DSP-20004

Riverfront at West Hyattsville Metro - Parcel 1 ETOD

STAFF REPORT

SUBJECT: Detailed Site Plan for Infrastructure DSP-20004
 Type 2 Tree Conservation Plan TCP2-001-2017-01
 Riverfront at West Hyattsville Metro - Parcel 1
 Expedited Transit-Oriented Development Project

SOUTH ELEVATION

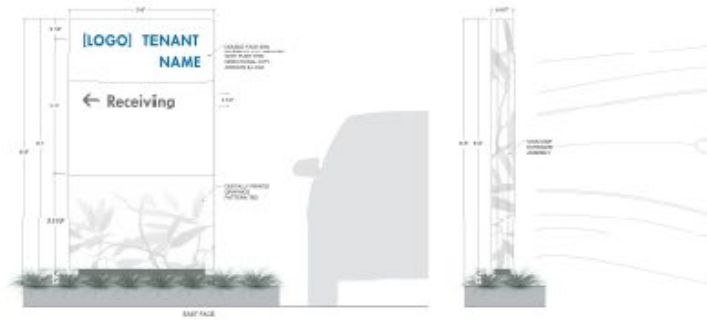
- g. Provide additional outdoor seating for the eating and drinking establishment, along the Ager Road frontage.
 - h. Provide more architectural details or artistic elements to the southern elevation to break up the mass and provide more visual interest.

SIGN B

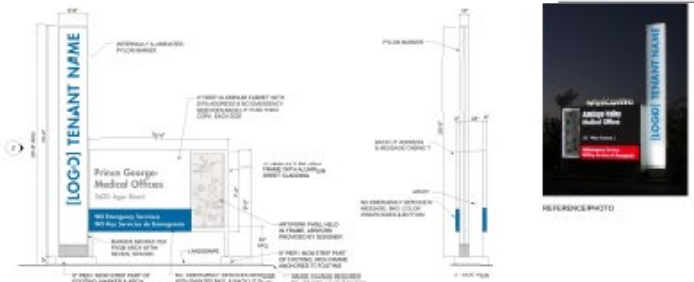
- f. Revise the sign plan to provide a signage schedule detailing all proposed signage, correctly label Sign B, label the width of all signs, and provide details and dimensions of the LED façade logo/graphic within the east elevation.
